Re: Water Feature Approval

Enclosed is the approved plan for the water feature at SkySong Phase IV.

Re: **Submittal Requirements for Water Features**  
Case Name: SkySong Phase IV / Case Number: 88-DR-2005#6 / 460-PA-2004

1 Main Entry Plaza - Small Condensate Cisterns  
 Scale: 1/8" = 1'-0"

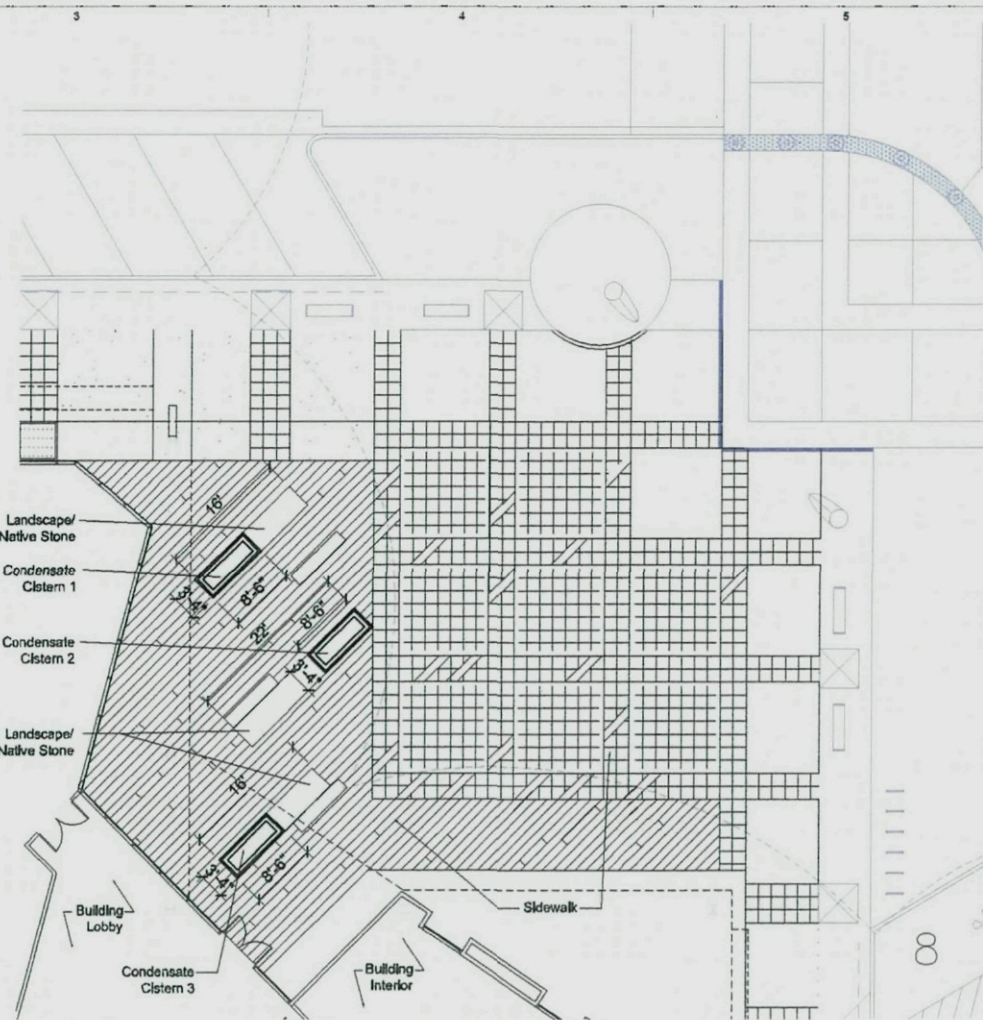
49-242 (b)(4)	Water features shall be: Designed using equipment that will minimize leakage throughout the life of the water feature.	The condensate cisterns will be made of cast-in-place concrete to minimize leakage and direct the flow to the landscape areas only.
49-242 (b)(5)	Water features shall be: Equipped with a recirculation pump. Filtered backwash shall be reused in a beneficial manner to surrounding plant material and landscaped areas.	The features will not use potable water. The source of the water will be from the condensate lines from the new building's HVAC system and used to supplement the landscape irrigation system.
49-242 (b)(6)	Water features shall be: Separately metered if using more than one thousand (1,000) gallons of water per day.	The features will not use potable water and will not tap into the domestic water system.
49-242 (c)(1)	Water features shall be: Operational only during normal business hours.	The features will not use potable water. The condensate will vary throughout the day and year based on the availability of condensate water from the new building's HVAC equipment.

49-242 (c)(2)	Water features shall be: Sited allow significant environmental enhancement to on-site users and used to cool surrounding area and mask objectionable noises. Allowable examples: Courtyards and restaurant seating areas not visible from the street.	The condensate cisterns will be ephemeral water features. They will provide a learning experience for the appreciation of water in the Sonoran Desert. The flow of condensate water will vary throughout the year, but will be most prominent in the warmer months. Depending on the flow rate, they will provide a unique aural and visual experience as people sit in the plaza or make their way to the building lobby.
49-242 (d)	Any person installing a water feature must provide a water feature plan to the city and obtain a permit before commencing construction.	Drawings as required will be submitted to obtain a construction permit.
49-242 (e)	<ul style="list-style-type: none"> <li>(1) Any system that injects or drops water into the air solely for the purpose of cooling a confined air space.</li> <li>(2) Water parks.</li> <li>(3) Single-family residential properties.</li> </ul>	These items do not describe the intent of the proposed condensate cistern concept.

1 Main Entry Plaza - Small Condensate Cisterns (Qty=3)  
Scale: 1/8" = 1'-0"

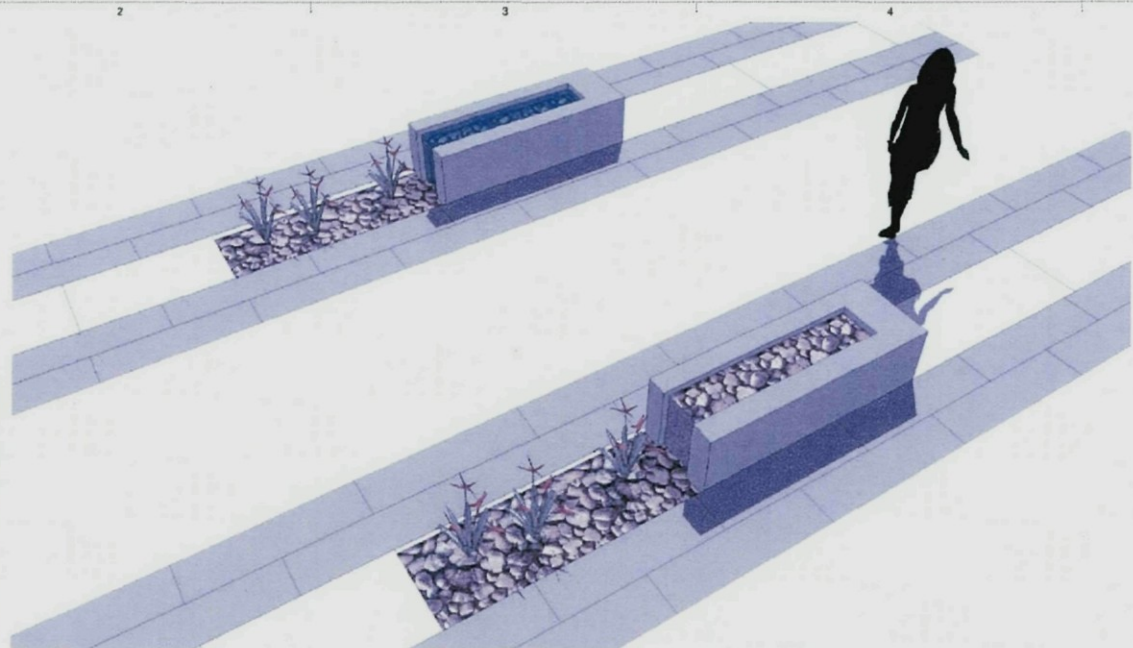
Dimensions (LxWxH): 22' max. x 3'-4"x2'-0"

2 Parking Entry Plaza - Large Condensate Cistern (Qty=1)  
Scale: 1/8" = 1'-0"

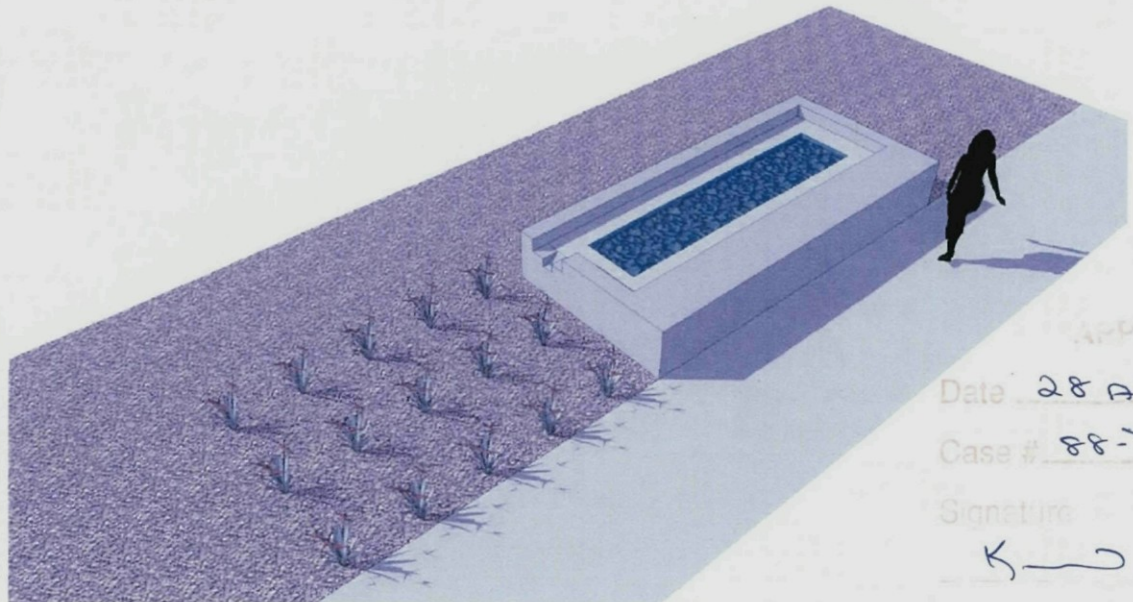
Dimensions (LxWxH): 15'-0"x7'-0"x 2'-0"
